**From:** Chong Hermose <[REDACTED]>  
**Sent:** 25 November 2025 08:25  
**To:** tpbpd/PLAND  
**Cc:** [REDACTED]  
**Subject:** A/YL-SK/431 : 回覆部門意見 ( Drainage Proposal )  
**Attachments:** Temporary Drainage Proposal for\_SK431\_20251125.pdf  
**Categories:** Internet Email

# **TEMPORARY DRAINAGE PROPOSAL (Final)**

**APPLICATION NO. A/YL-SK/431**

**Response to Comments on draft Temporary Drainage Proposal (Issue 3)****1. Comments from DSD/YL**

Appendix C  
- Drainage  
Layout

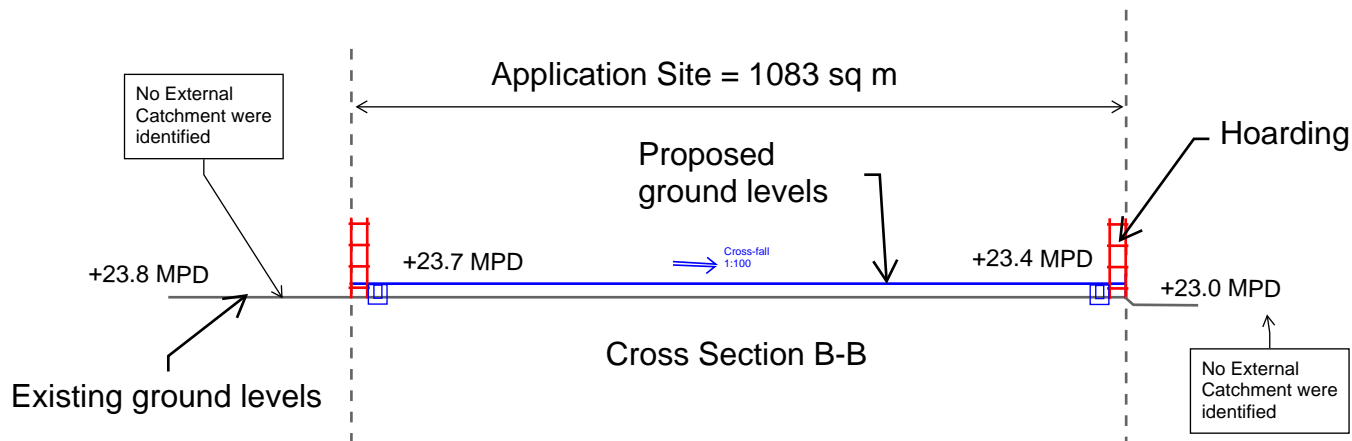
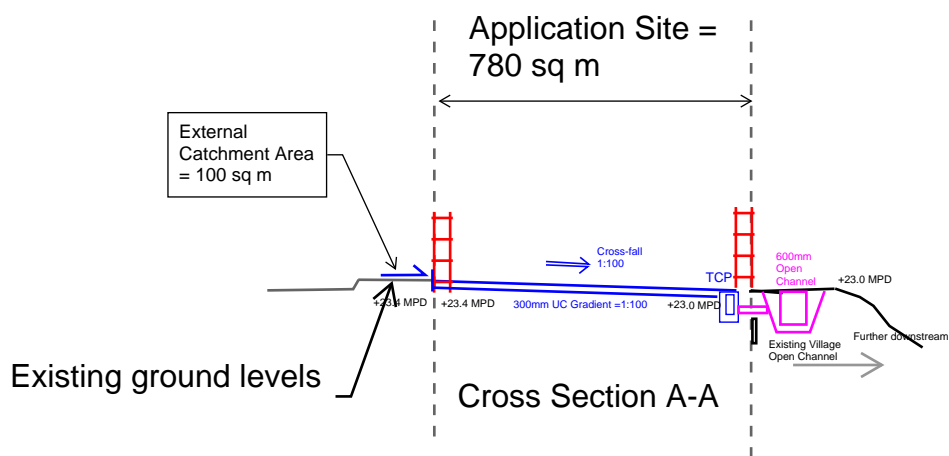
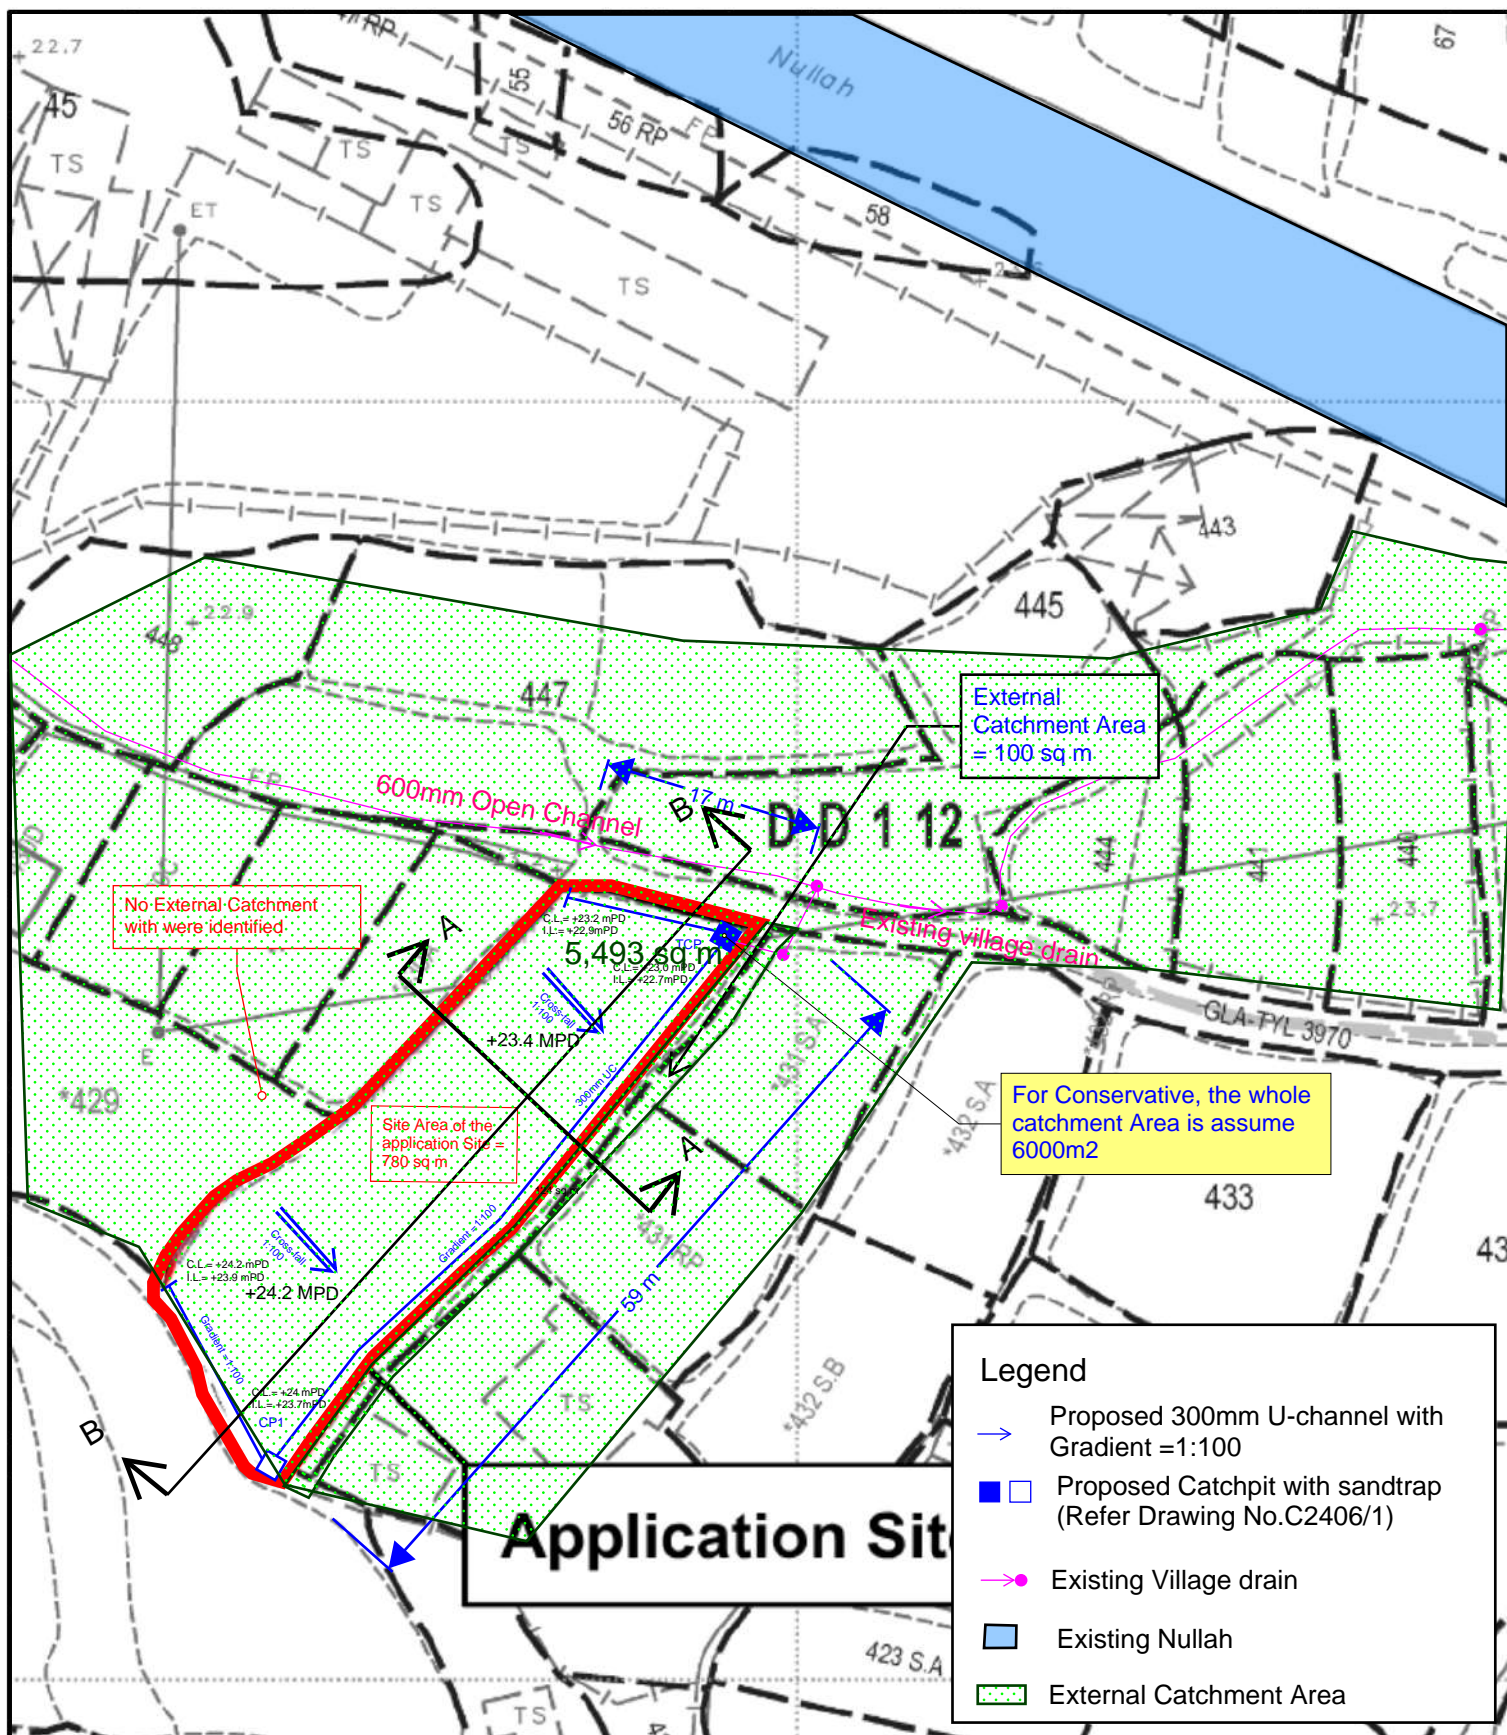
F.	The proposed site level showed in drawing no. 202571 IB is not tally with the site levels showed in drawing no. 20231021	Noted and revised.
G.	Please show the cross section at the longitudinal direction of the site in the Drawing.	Noted and the cross section is provided.

H.	Please indicate C.L., I.L and B.L details of the terminal manhole, proposed channel and existing channel at discharge point in the drawing.	Noted and provided in Appendix C – Drainage layout.

**APPENDIX D**  
**DESIGN CALCULATION OF THE PROPOSED DRAINAGE**

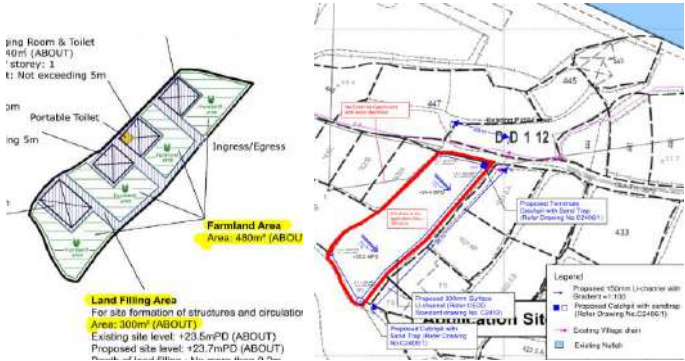
<b>No.</b>	<b>Comments</b>	<b>Response</b>
A.	Please refer to the Stormwater Drainage Manual Corrigendum No. 1/2024 (26 March 2024) for the design calculations.	Noted with thanks. The design calculations are revised accordingly. The Stormwater Drainage Manual Corrigendum No. 1/2024 (26 March 2024) are adopted.

C.	The ground level at the eastern side of the application site is higher. The applicant should review the existing site condition, take into account any overflow and review the total catchment area adopted in the drainage design and calculation.	The additional catchment area is incorporated in the drainage design calculation.

I.	Calculation to demonstrate the downstream drainage system receiving the discharge from the development has adequate spare capacity to accommodate the runoff is required.	Noted and included in the Appendix D – Design Calculation.
